28 June 2019

Alison Johnstone
Silver Fern Farms Ltd
RD2 Fairton
PO Box 30
ASHBURTON 7740

SILVER FERN FARMS TAKAPAU CONSENT RENEWALS SECTION 92 REQUEST

SCALE : 1:20,000 (A4)
 0 100 200 400 600
 METRES

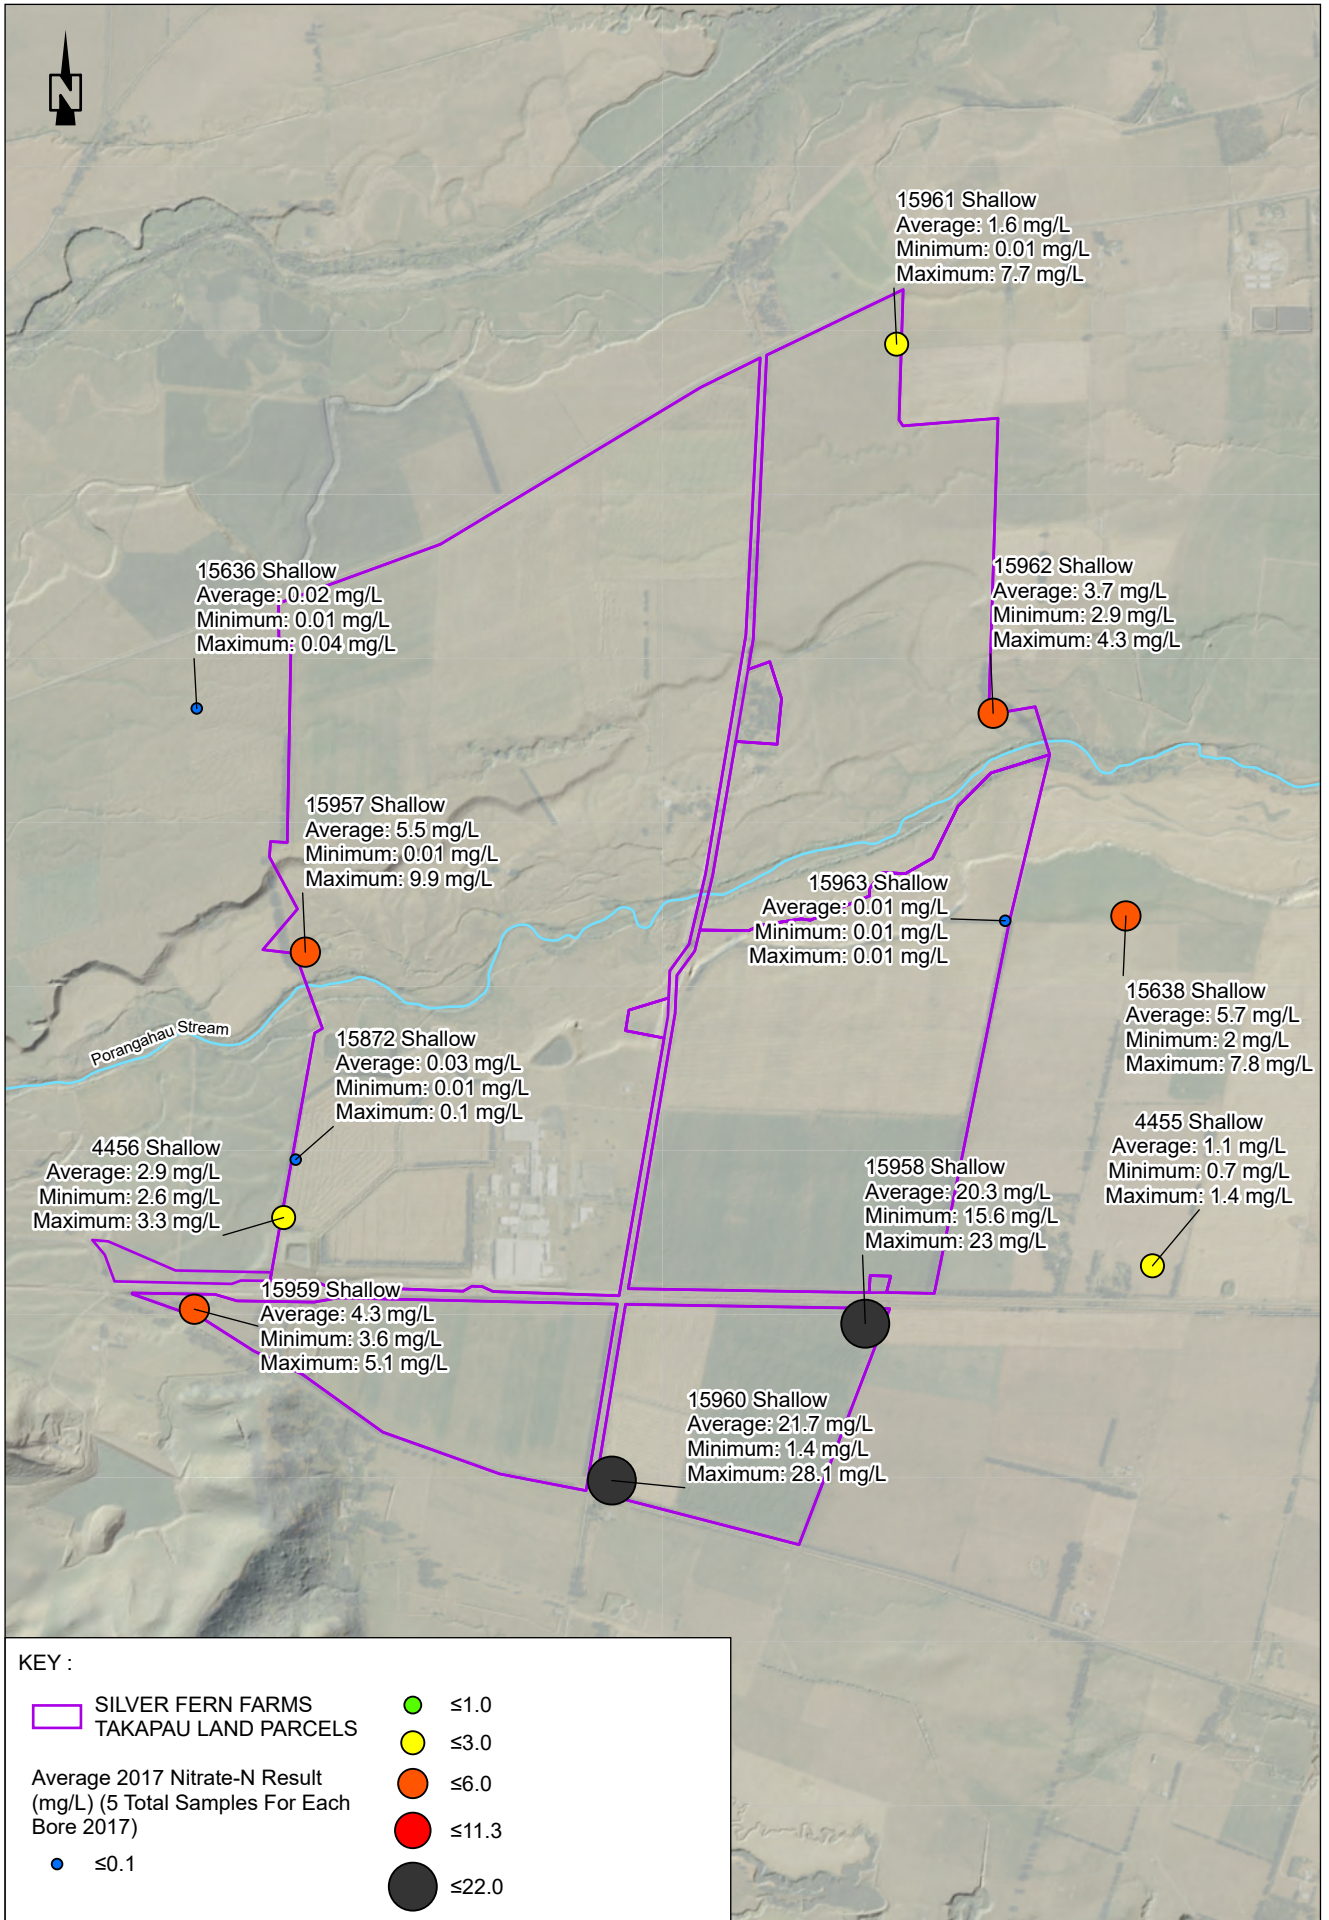
7. A map showing interpolated groundwater elevation contours in metres above mean sea level (mASML) for the shallow and deep aquifers. Provide a piezometric surface plot during high and low river stage times for the shallow and deep aquifers to assess any changes in groundwater flow direction under different climatic conditions.

The interpolated groundwater elevation contours for both shallow and deep monitoring bores for different stage conditions are shown in Figures 3a to 3d, appended. As with the other elevation contours, there is uncertainty in these, particularly away from the bores. However, the contours suggest that there are no significant changes in the general inferred groundwater flow patterns with different stream flows/stage.

Overall, the figures indicate a similar groundwater contour pattern to that presented in Figure 7 in PDP (2010), with a slightly more north-easterly direction inferred for the groundwater flow direction in the southern parts of the site.

FIGURE 4A : Nitrate-Nitrogen Results 2017
Shallow Aquifer

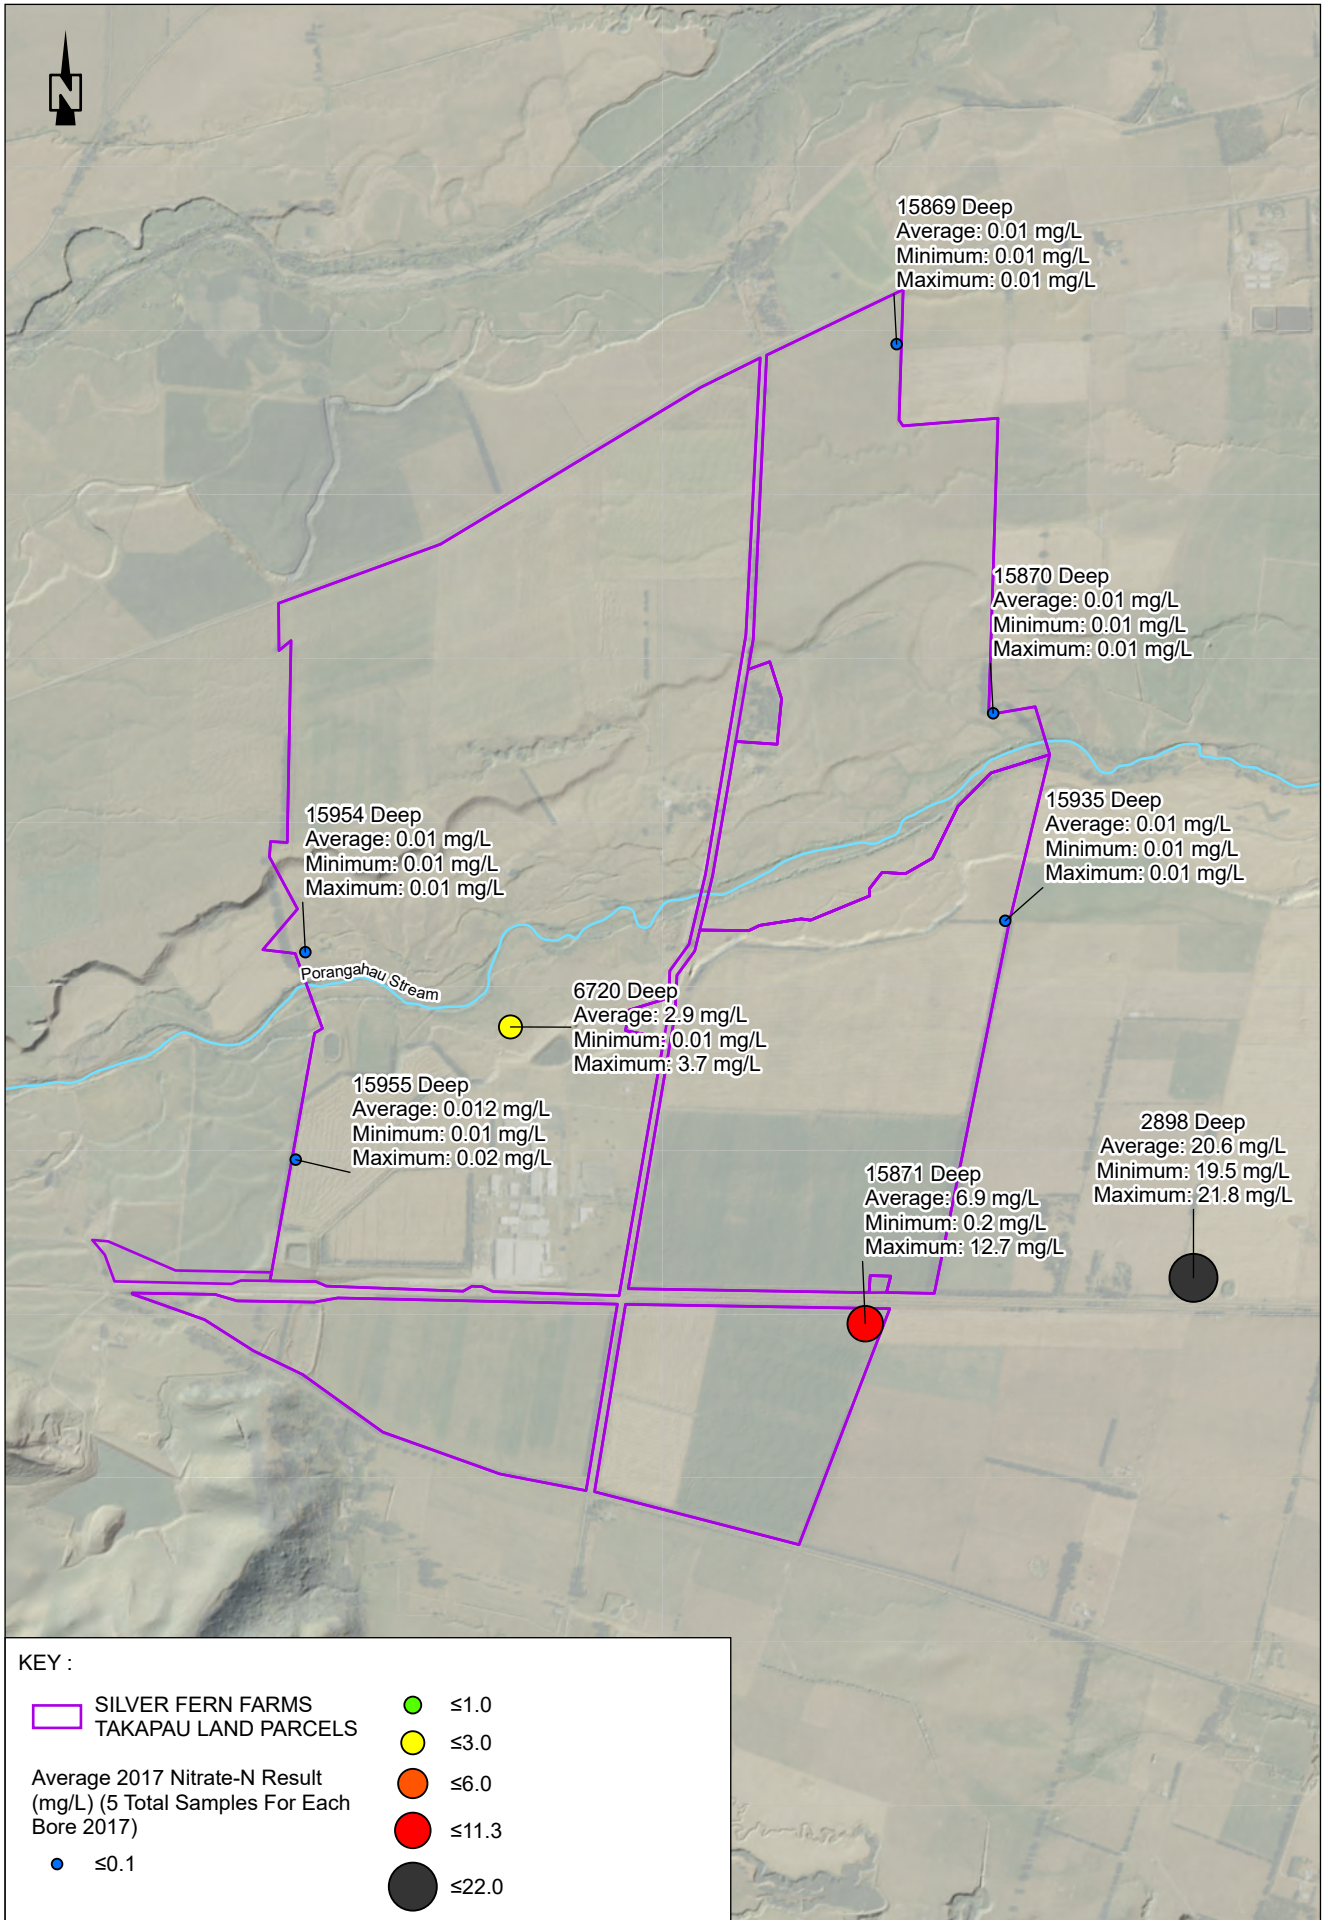
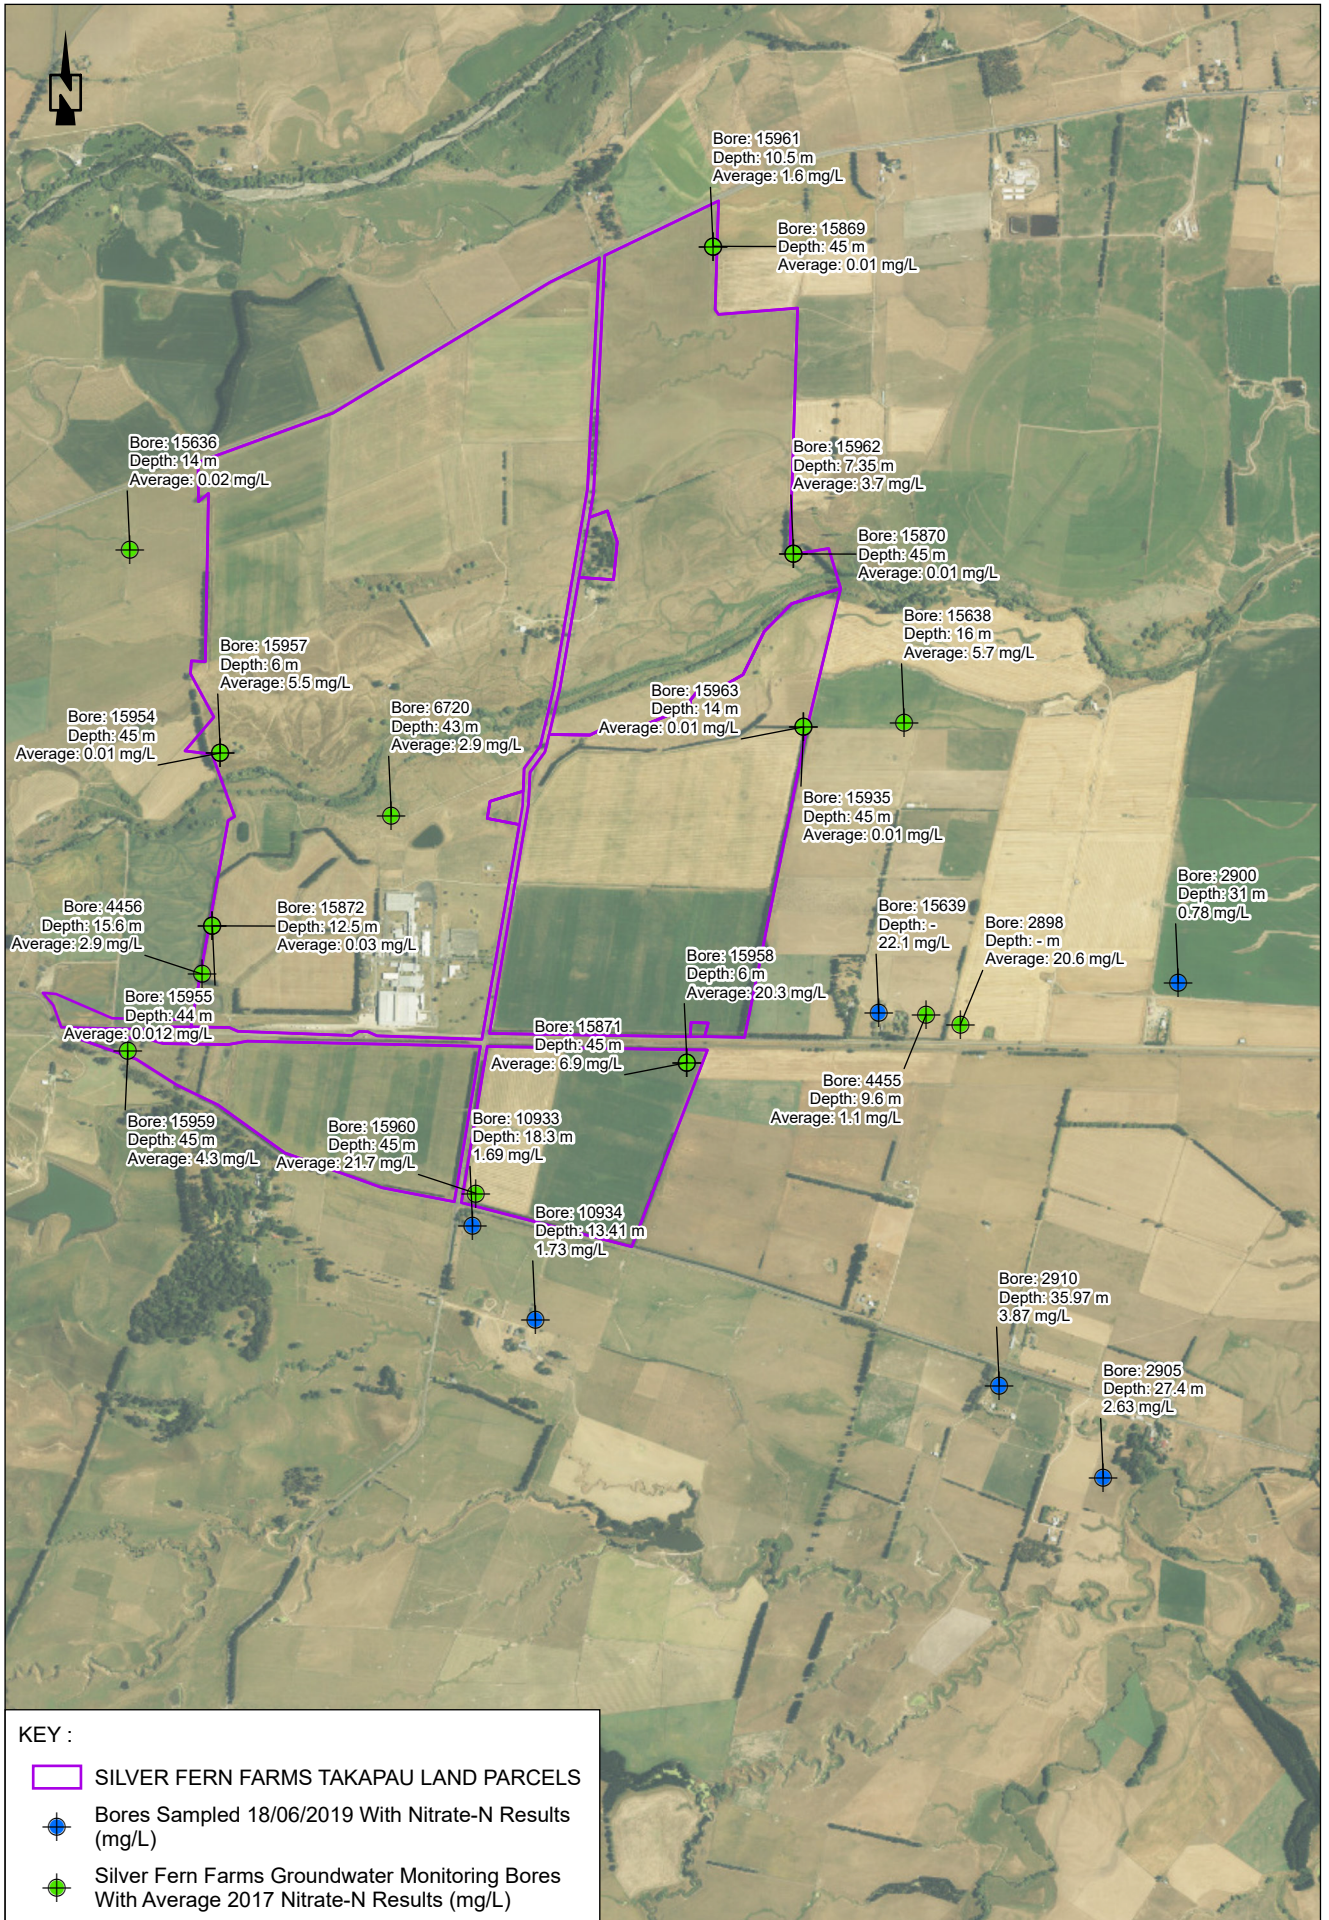
8. A map showing interpolated contours of nitrate nitrogen concentration (mg/L) in the shallow and deep aquifers.

We do not consider that contours of nitrate-nitrogen concentrations can be reliably defined based on the monitoring data, even though there are multiple monitoring bores at and around the site. Nitrate transport varies depending on a number of variables, including dispersion characteristics and aquifer heterogeneity and input concentrations, which in this case have varied considerably over time and spatially. Instead, we have responded to this request with maps of measured concentrations in the different bores, with symbol size/colour based on the concentration to illustrate locations of higher and lower concentrations.

These maps are shown in Figure 4a and 4b, appended for the shallow and deep aquifers, respectively, and show the averages, maximum and minimum for sampling data we have been provided for the 2017 year. They clearly illustrate the hot spots that occur in the southern areas. As outlined in PDP (2018), historic border dyke irrigation of the process wastewater occurred on Blocks B, C and D. As outlined in PDP (2010), modelling undertaken suggested it could take up to 43 years for the plume of nitrates to fully pass through the groundwater in the locations of the down-gradient monitoring bores.

9. A map showing the extent of the area where an exceedance of the drinking water standard is likely to occur (in both shallow and deep aquifers), and identify (using databases of known wells and surveys or other methods) all domestic water supply bores within this affected area.

Silver Fern Farms have undertaken a sampling round in June 2019 of down-gradient supply bores on neighbouring properties, including bore 2900. This sampling has included a number of bores to the southeast of the site, even though they are considered less likely to be affected, to confirm no high nitrate-nitrogen levels are occurring.

The results of the sampling are shown in Figure 5, together with average readings for 2017 for the regular monitoring bores for comparison. This shows no exceedances of the Maximum Acceptable Value of 11.3 mg/L in the Drinking Water-Standards for New Zealand in the bores, with the exception of bore 15639. This is not unexpected given it is upgradient of the Layers Bore (2898), where high concentrations are still occurring. Silver Fern Farms have confirmed that, while bore 15639 was included in the sampling, it is not used for drinking water supply.
